ZONING COMMISSION
District of Columbia
CASE NO.19-09
EXHIBIT NO.14

APPLICATION FOR DESIGN REVIEW

THE RESIDENCES AT KENILWORTH
 KENILWORTH PARK, WARD 7
 WASHINGTON, DC

Responses to DDOT Staff Report | Recommendations

Site Access & Circulation | With Kenilworth Courts PUD

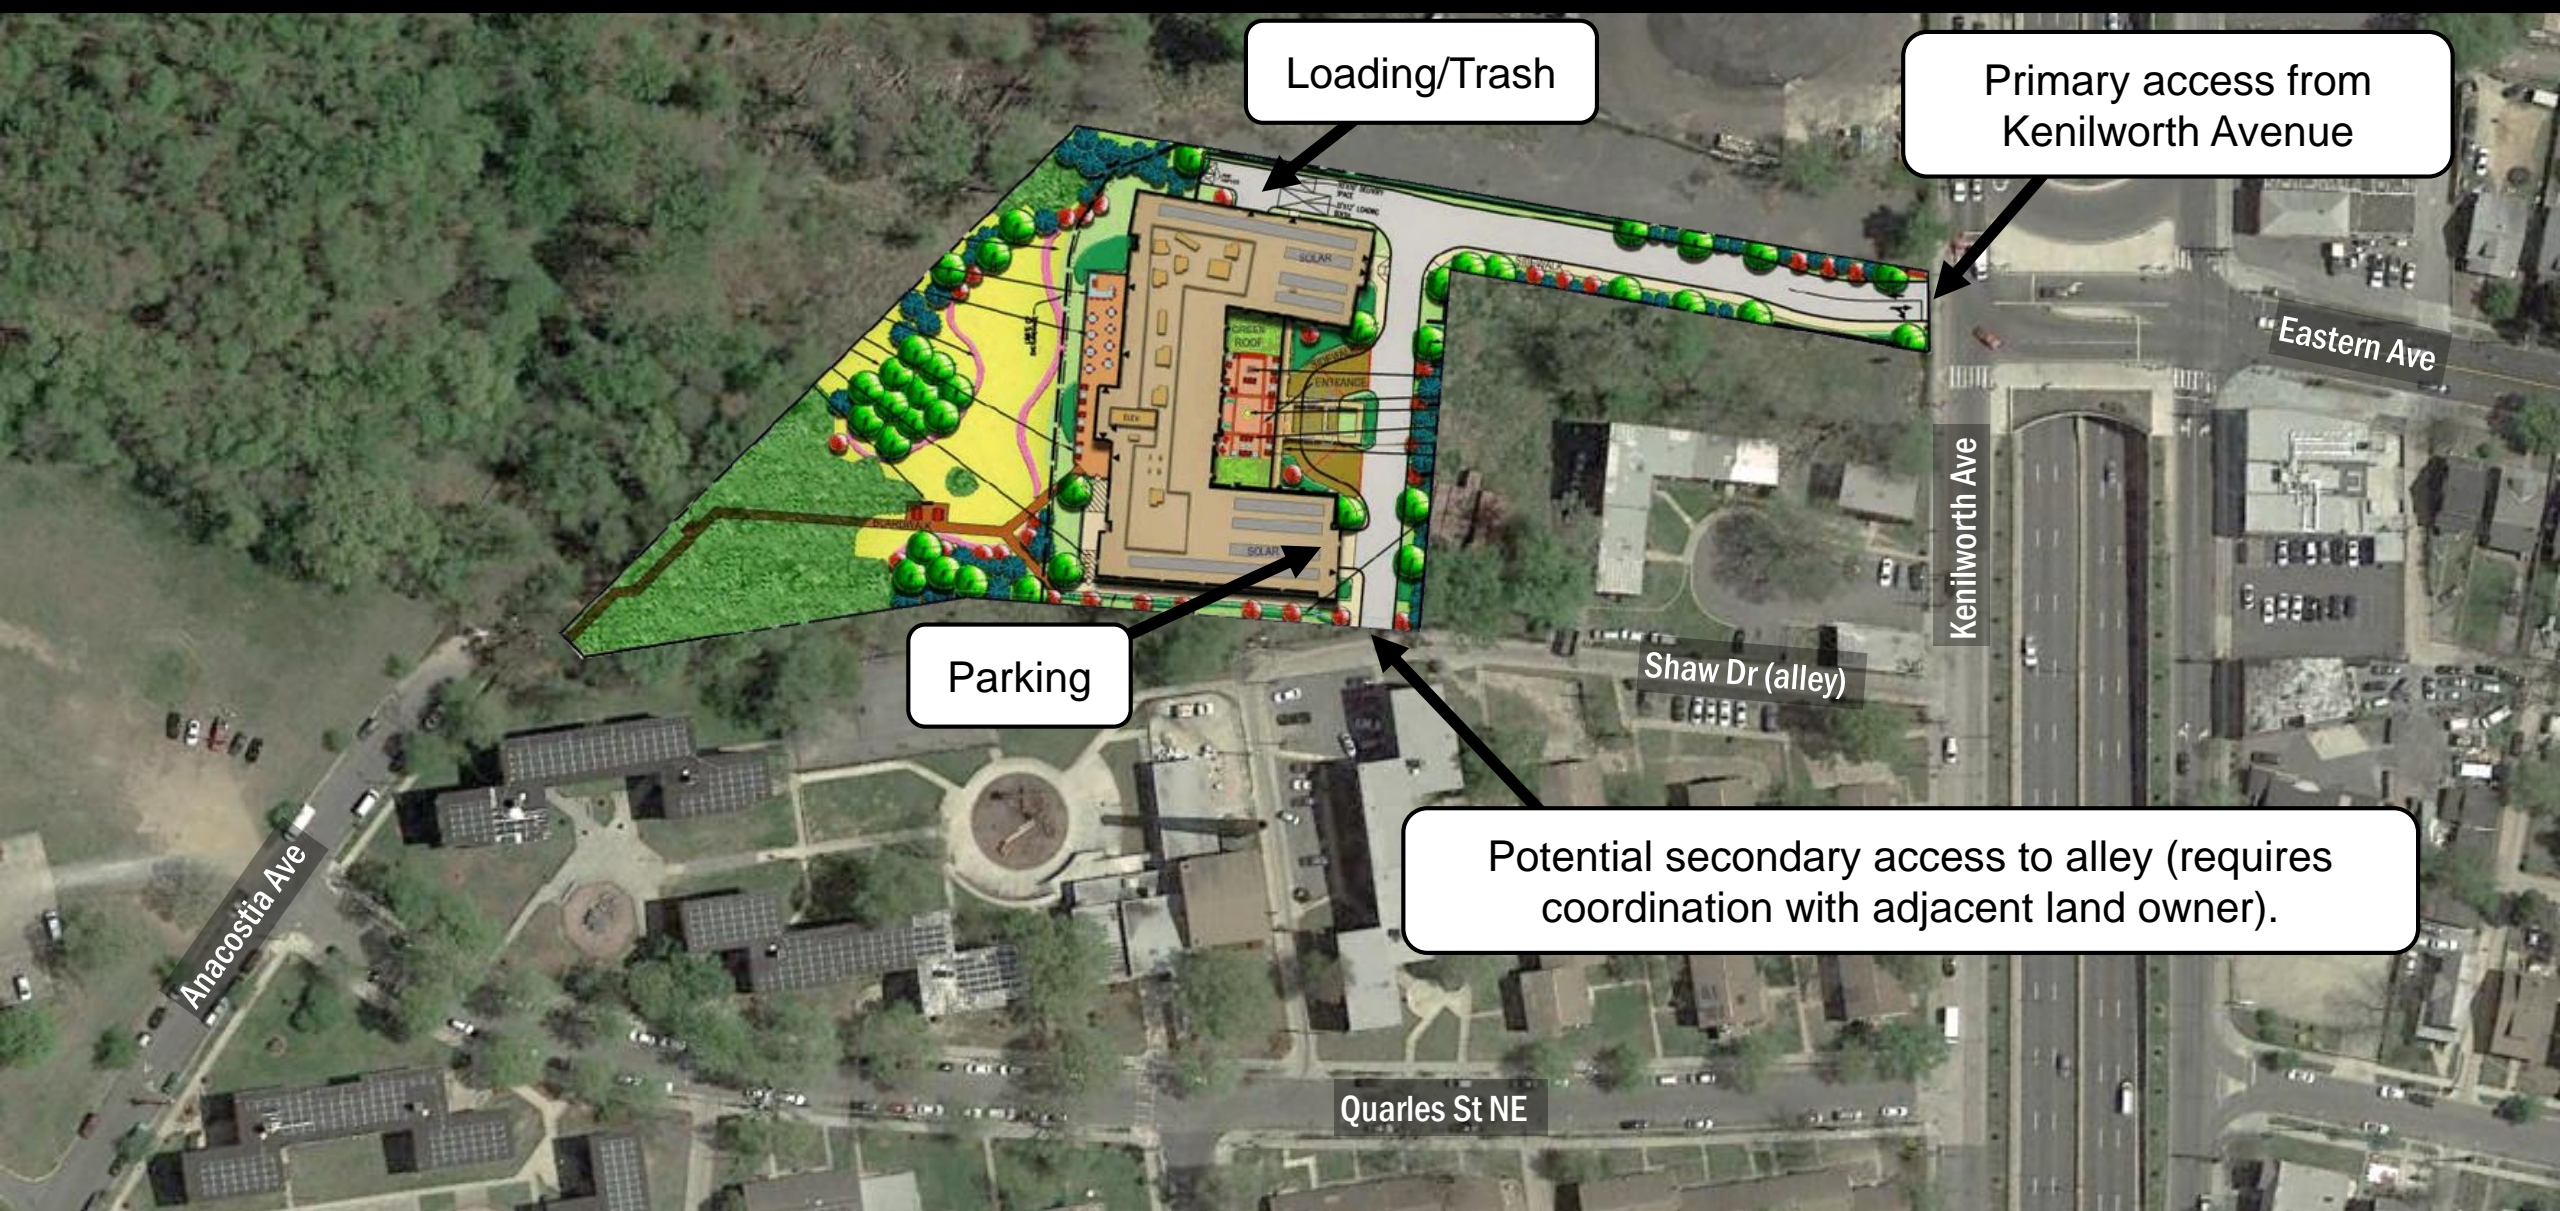
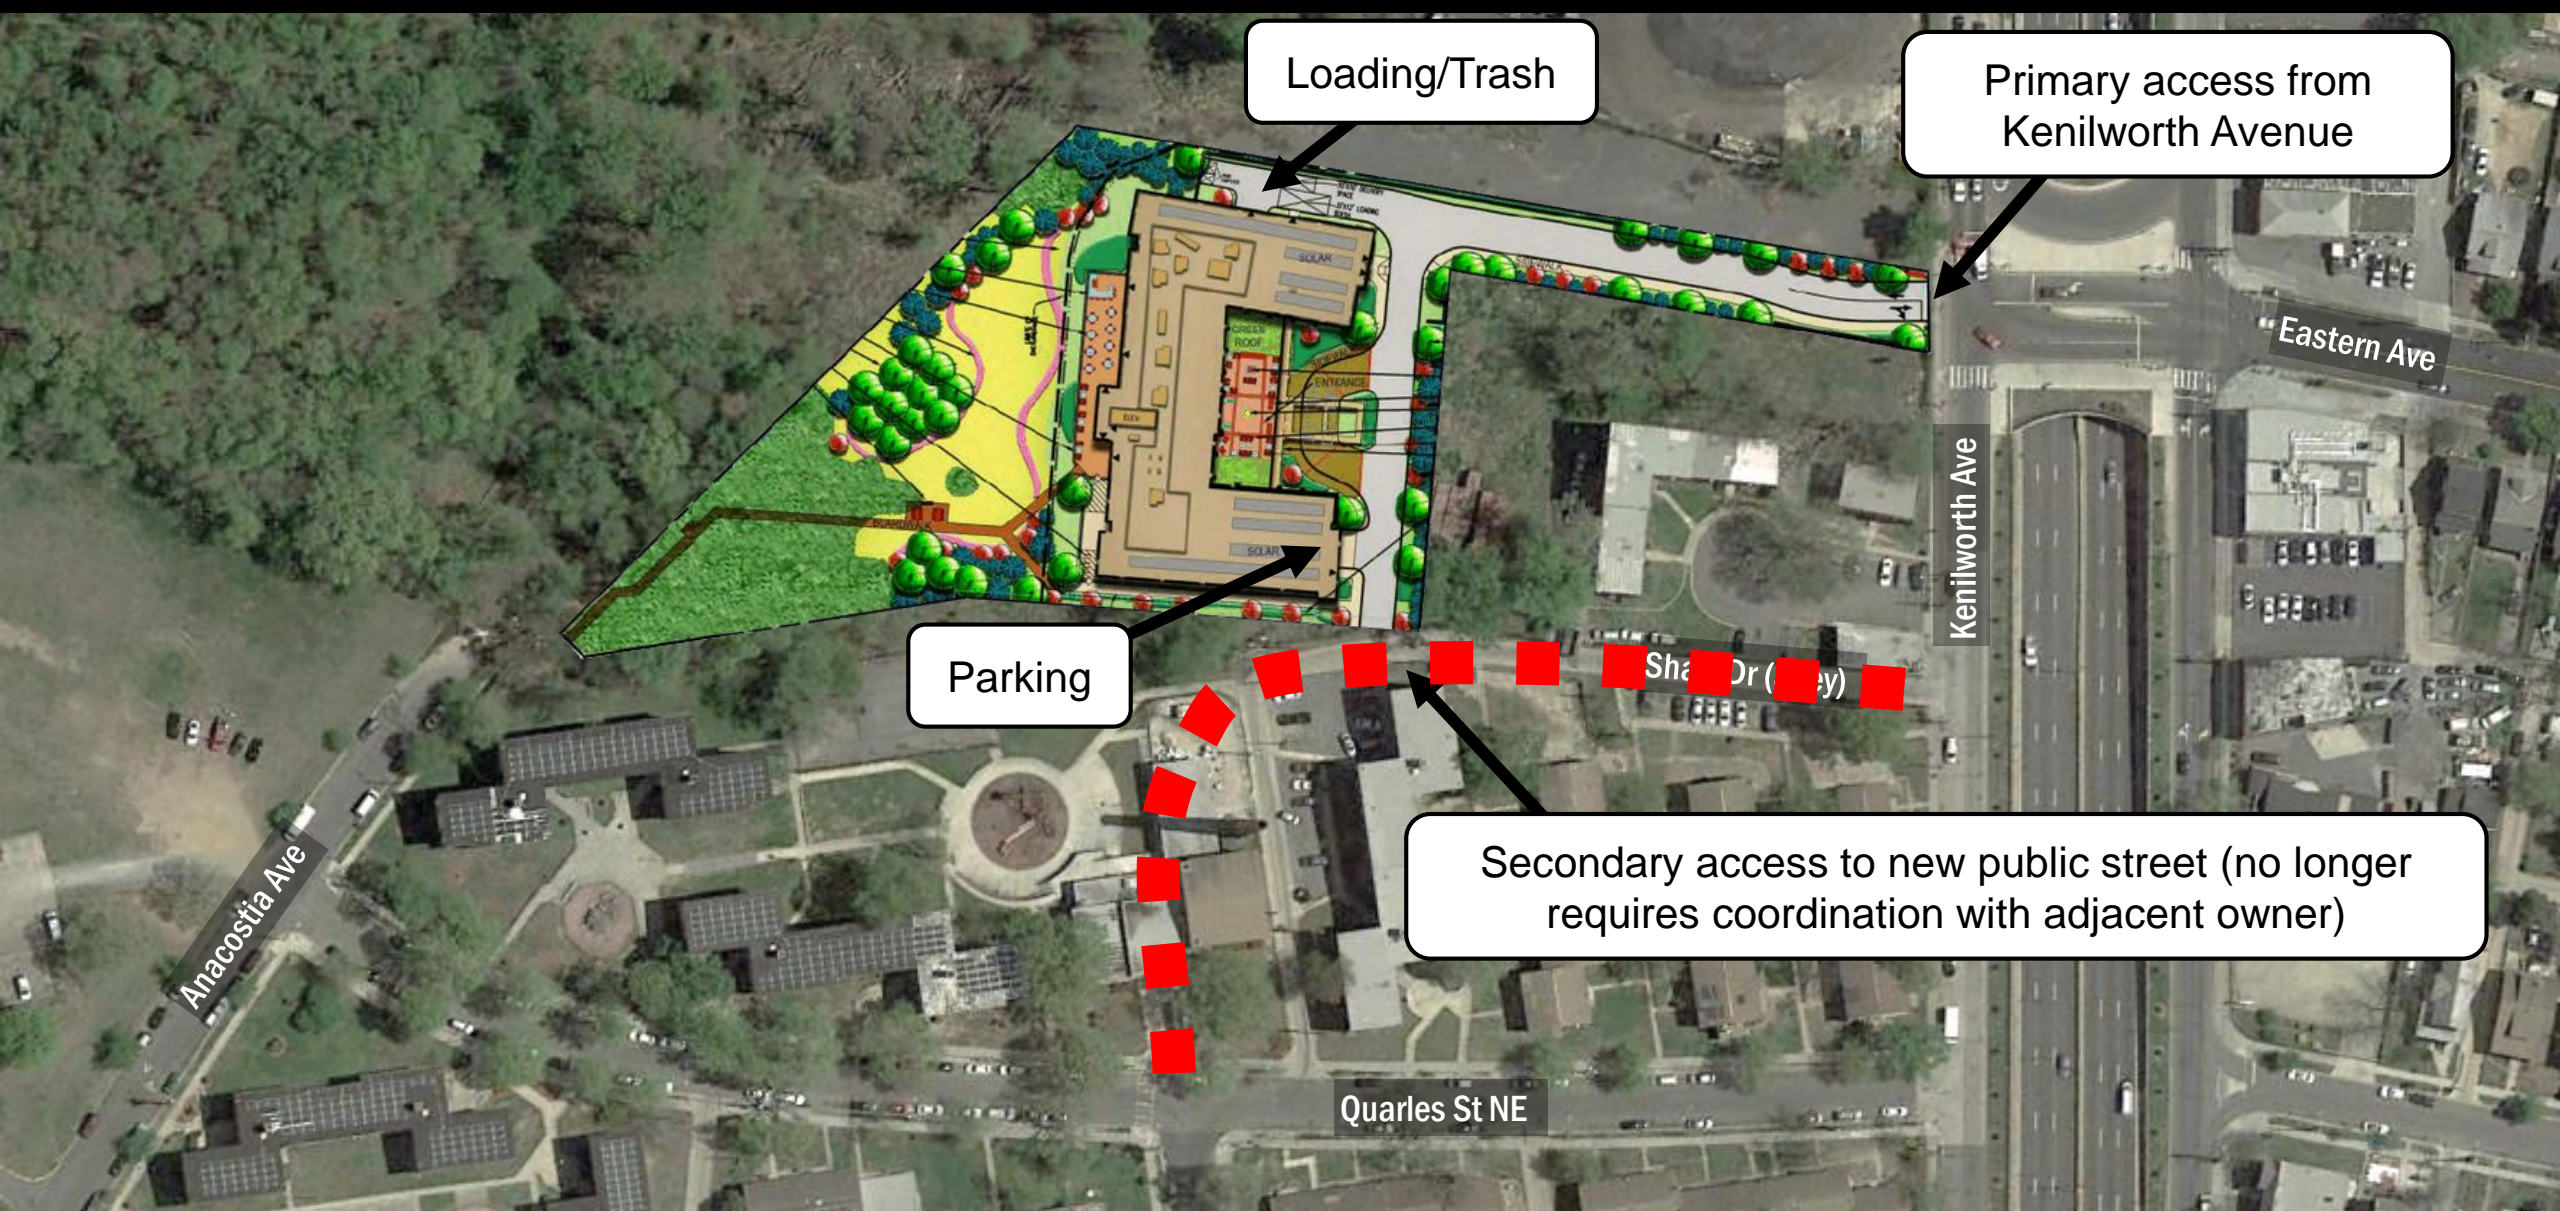
DDOT Comment	Applicant Response
“Fund, design, and construct any new or relocated traffic signal equipment and all required geometric modifications at the intersection of Kenilworth Avenue NE and Eastern Avenue, as required by and subject to approval by DDOT.”	Applicant agrees
“Implement the revised Transportation Demand Management (TDM) plan proposed in the Applicant’s May 21, 2019 CTR, for the life of the project, with the minor additions requested by DDOT”	Applicant agrees with one change: Replace: “Will meet the ZR16 requirements for showers and lockers for use by employees. Applicant should clarify the number that will be provided” with: “Provide a minimum of 2 showers and 20 lockers for use by employees.”
“Dedicate the right-of-way necessary to accommodate extensions of both Eastern Avenue and Anacostia Avenue through the site, as called for in the Plan of a Permanent System of Highways for the District of Columbia.”	Applicant agree with the following change: “The Applicant will not obstruct nor ask for compensation for the land required for the right-of-way necessary to accommodate extensions of both Eastern Avenue and Anacostia Avenue through the site, as called for in the Plan of a Permanent System of Highways for the District of Columbia.”

DDOT Comment	Applicant Response
<p>“Provide a detailed curbside management and signage plan consistent with current DDOT policies since the signage along Kenilworth Avenue will need to change to accommodate the Applicant’s new curb cut”</p>	<p>Applicant agrees – will coordinate during Public Space</p>
<p>“Public space, including curb and gutter, street trees and landscaping, street lights, sidewalks, curb ramps, and other features within the public right-of-way are expected to be designed and built to DDOT standards”</p>	<p>Applicant agrees – will coordinate during Public Space</p>
<p>“The curb cut to Kenilworth Avenue should be a maximum of 24-feet wide (currently shown as 28-feet), have a maximum of 15-foot curb radii, be at-grade with the existing street, and include pedestrian curb ramps and a crosswalk across the new intersection leg”</p>	<p>Applicant agrees – will coordinate during Public Space</p>

<p>“The curb radii for the connection to the alley to the south (Shaw Drive NE) should be reduced from 15-feet to 6-feet”</p>	<p>Applicant agrees – will coordinate during Public Space</p>
<p>“Typically, short-term bicycle parking racks are installed in public space. However, given the minimal amount of public space touching the site, the Applicant should install them on private property and follow the design requirements of ZR16 Subtitle C § 804. They should be moved from the garage and rear of the building to near the front door”</p>	<p>Applicant agrees – design has been updated to reflect this change</p>
